SUBJECT: Application for amends to Licenses DPR-31 & DPR-41, modifying
 Tech Spec limiting condition for operation for control room
 ventilation sys to allow implementation of mods to satisfy
 NUREG-0737, Item III. D. 3. 4. Fee paid.

Re: Turkey Point Units 3 and 4
Docket Nos. 50-250 and 50-251
Proposed License Amendment
Control Room Ventilation

ATTACHMENT I

SAFETY AND NO SIGNIFICANT HAZARDS EVALUATION

FIGURE 1

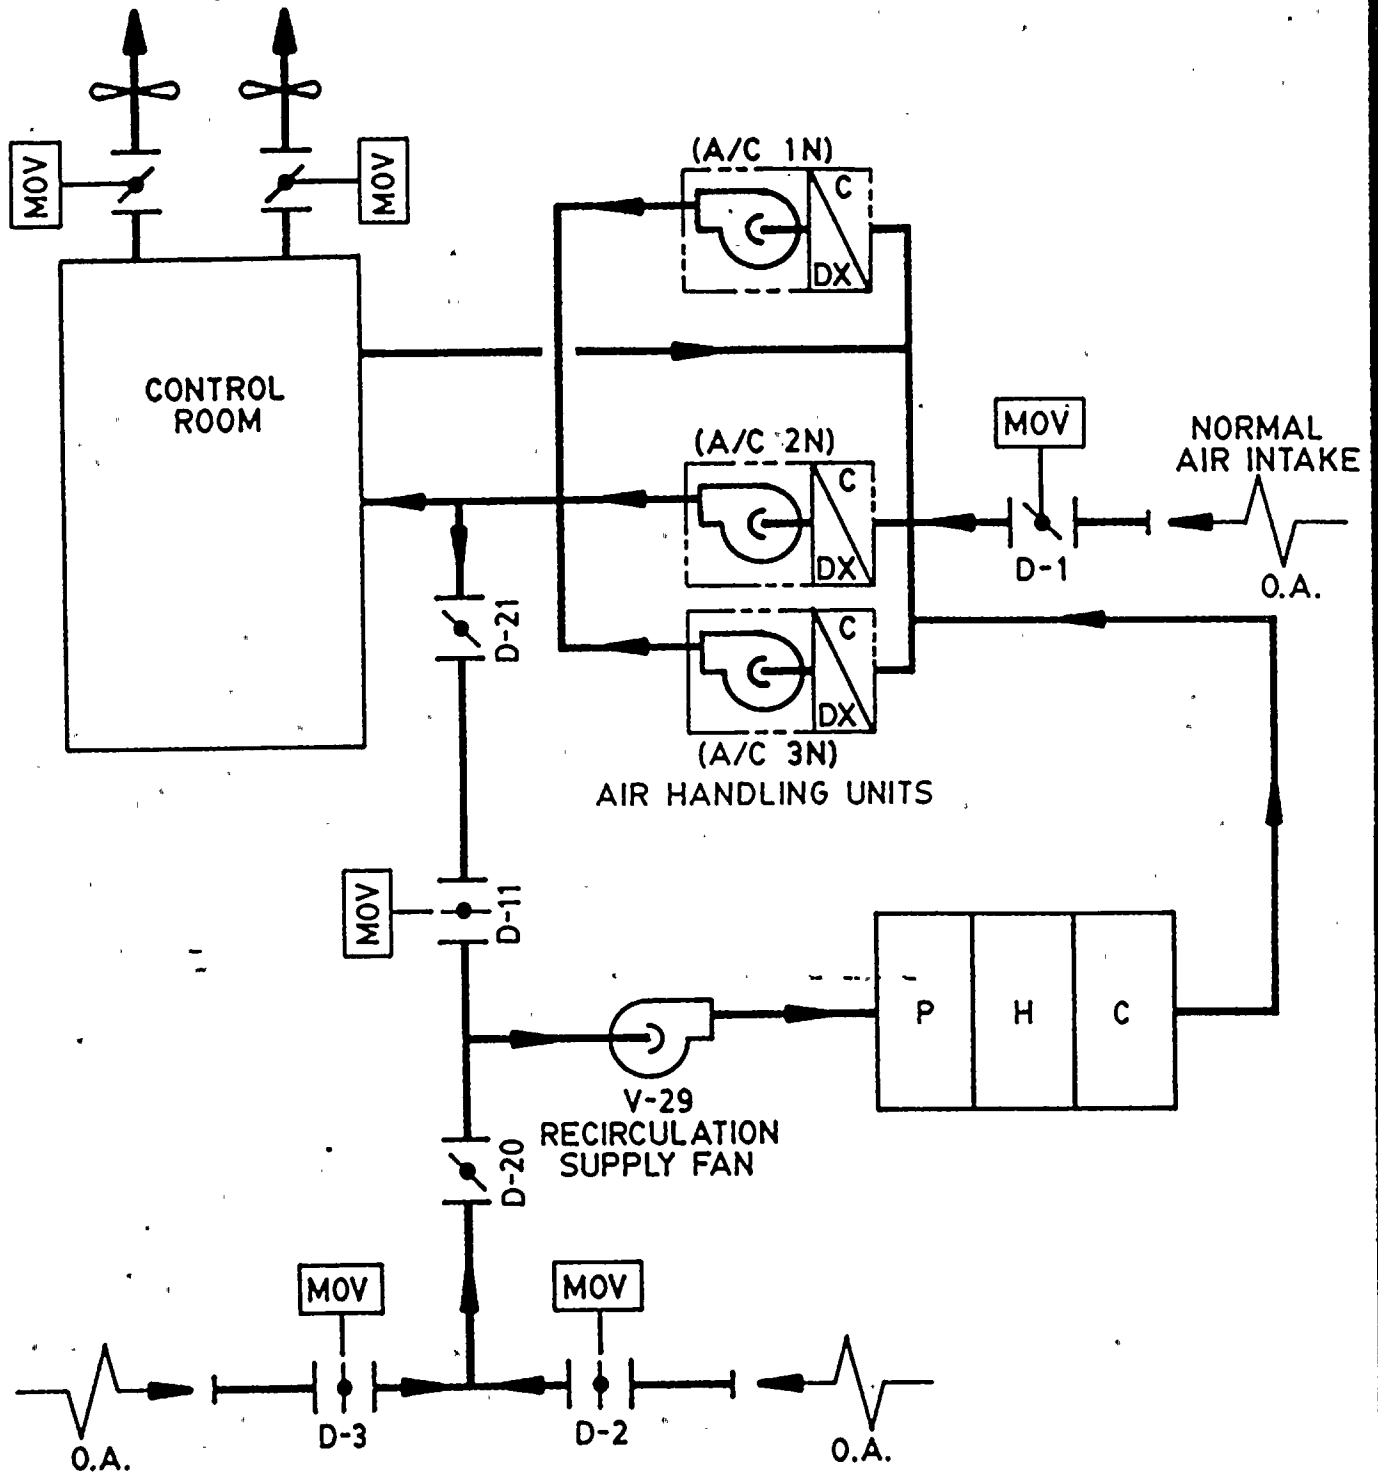
The operability of the control room ventilation system (see Figure 1) ensures that: (1) the ambient temperature does not exceed the allowable temperature for continuous-duty rating for the equipment and instrumentation cooled by this system, and (2) the control room will remain habitable for operations personnel during and following all credible accident conditions.

FIGURE 2

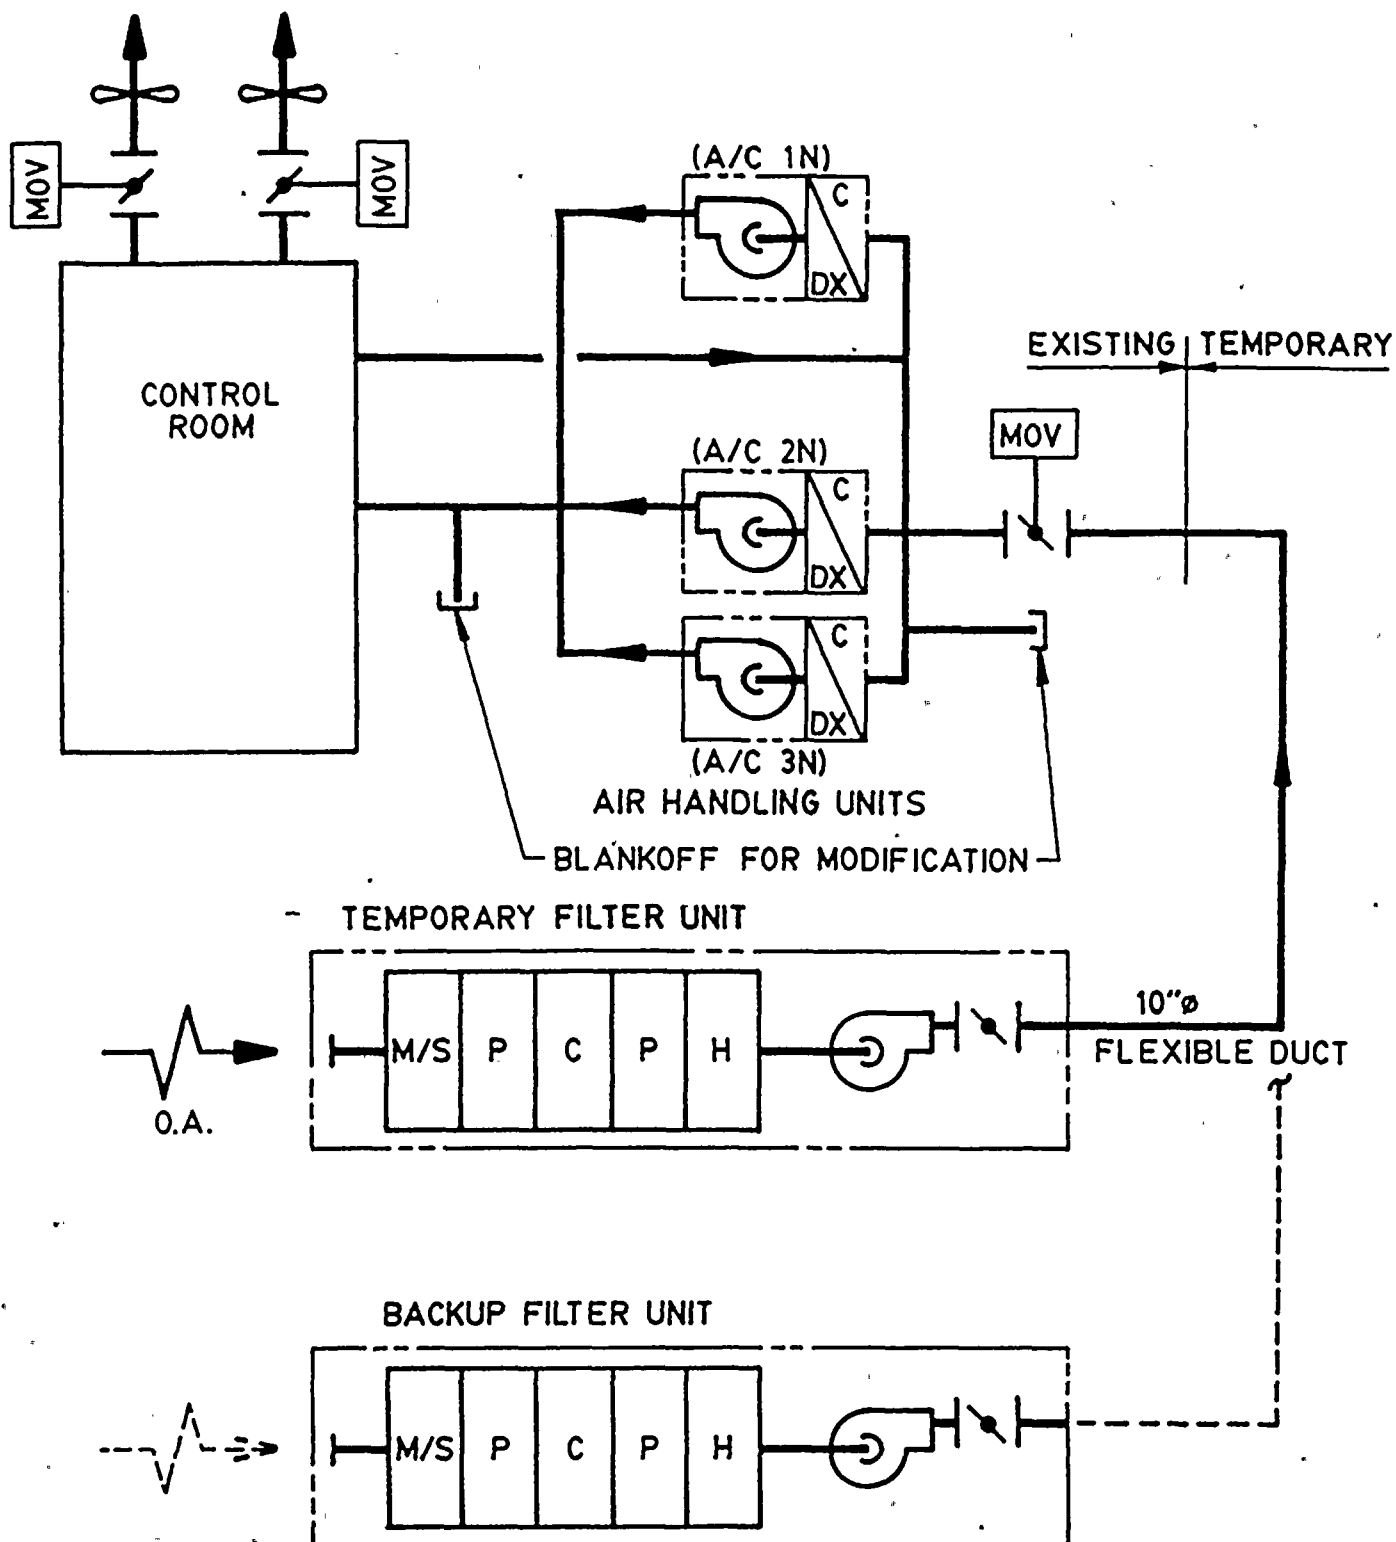
As noted above, the modification will primarily be confined to the emergency recirculation portion of the system, whose function is to mitigate the consequences of an accident by ensuring that the control room will remain habitable during and following design basis accident conditions. Under the current design, post-accident control room habitability is ensured by automatic actuation of the control room HVAC system to the emergency recirculation mode of operation in response to a containment ventilation isolation signal. This results, in part, in automatic closure of the normal air intake damper D-1, starting of the recirculation supply fan V-29, and opening of dampers D-2, D-3 and D-11. Under this configuration, approximately 250 cfm of outside air makeup is obtained via dampers D-2 or D-3 to provide a positive control room pressure thereby minimizing the amount of unfiltered in leakage and ensuring an acceptable control room environment. Therefore, to ensure a commensurate degree of protection during the 45 day period required to implement the modifications, a temporary filtration system consisting of a high efficiency particulate air (HEPA) and charcoal filter unit, together with an air supply fan and interconnecting duct assembly will be installed as shown on Figure 2. The use of this system as an alternate means of maintaining control room habitability under accident conditions is considered acceptable for the following reasons:

1. Design requirements for the temporary filtration system, including system sizing, air flow requirements, and filter unit efficiency will be sufficient to ensure that radiation exposure to control room personnel under accident conditions will be less than 5 rem whole body, or equivalent to any part of the body, consistent with the requirements for the existing recirculation system and General Design Criterion 19 (GDC-19) of Appendix A to 10 CFR Part 50. Analyses performed to support use of the temporary filtration system have shown that for an expected system flowrate of 800 cfm, and filter efficiencies of 99, 95, and 95 percent for removal of particulate, elemental iodine and organic iodine respectively, the cumulative whole body dose for the 30-day period following a LOCA would be less than GDC-19 limits assuming worst-case accident conditions.

2. Necessary system components including the filter unit supply fan and control room air intake damper D-1, will be powered from existing safety-grade plant busses thereby ensuring operability of the system under loss of offsite power conditions. In addition, the temporary system will be designed to operate continuously during the 45-day modification period without automatic actuation or control functions. Also, no manual actions are required to support system operation under accident conditions. Therefore, operability of the system as required to mitigate the effects of design basis accidents concurrent with a loss of offsite power is ensured.

3. In the unlikely event of a filter unit failure during the 45-day modification period, a second, duplicate unit and associated supply fan will be available onsite and ready for installation to restore system operation. Should the temporary system be rendered inoperable as a result of equipment failure, system testing, or completion of recirculation system modifications, existing Technical Specification action statements for inoperability of the control room ventilation system will apply thereby ensuring safe plant operation in accordance with existing Technical Specification requirements.

4. Functional testing of the temporary system including the backup filter unit will be performed to demonstrate operability prior to use and after 720 hours of operation. Testing requirements will be consistent with current Technical Specification surveillance requirements for the existing recirculation system and will include appropriate visual inspections, leak tests, and airflow distribution tests.

FIGURE 3

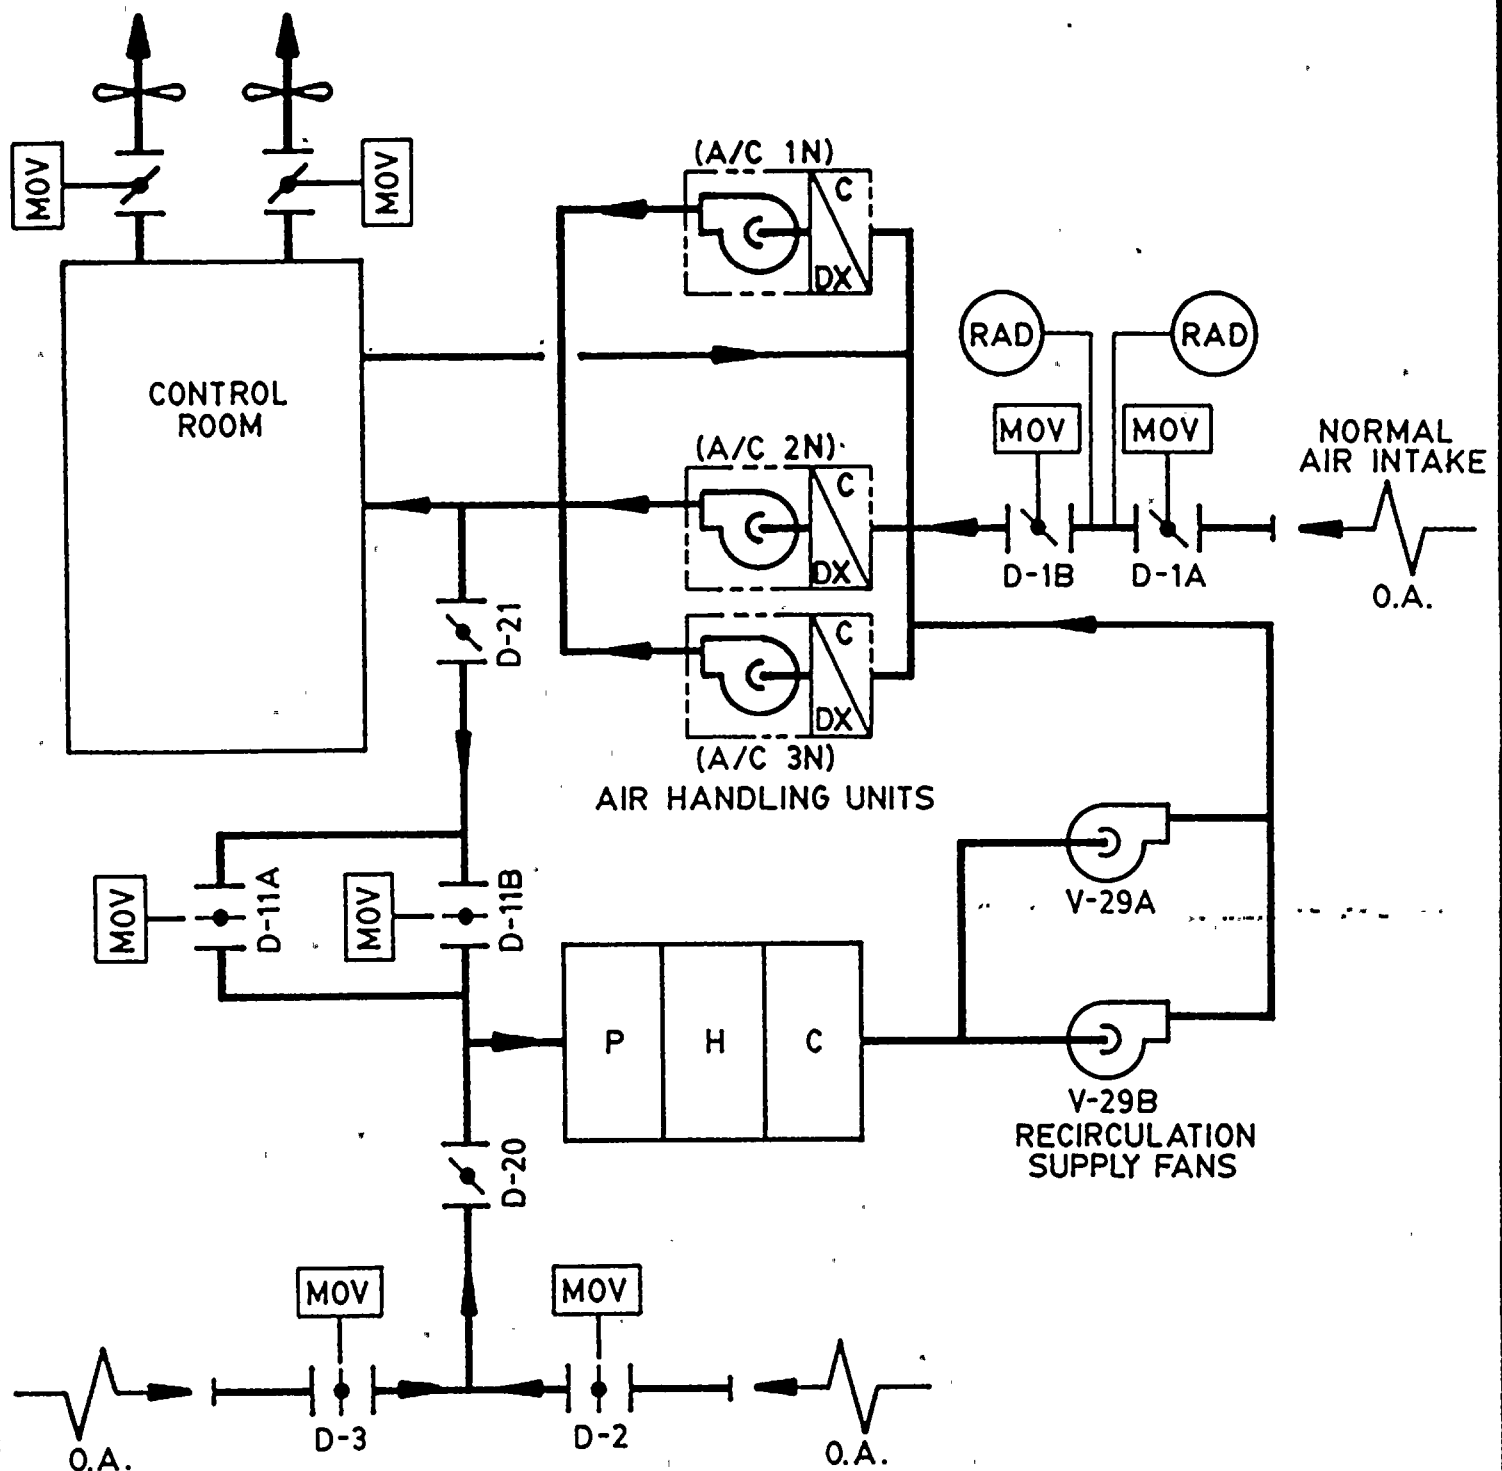
6. Operator training will be conducted and temporary procedure changes implemented as necessary to support safe and reliable operation of the temporary filtration system. However, as noted in item 2 above, the system will be designed to operate continuously during the modification period and require no manual actions to support operation under accident conditions. Therefore, necessary training and procedure changes will be minimal. Upon completion of the required system modifications and prior to removal of the temporary system from service, necessary procedure changes will be implemented to support use of the permanent control room HVAC system as shown on Figure 3.
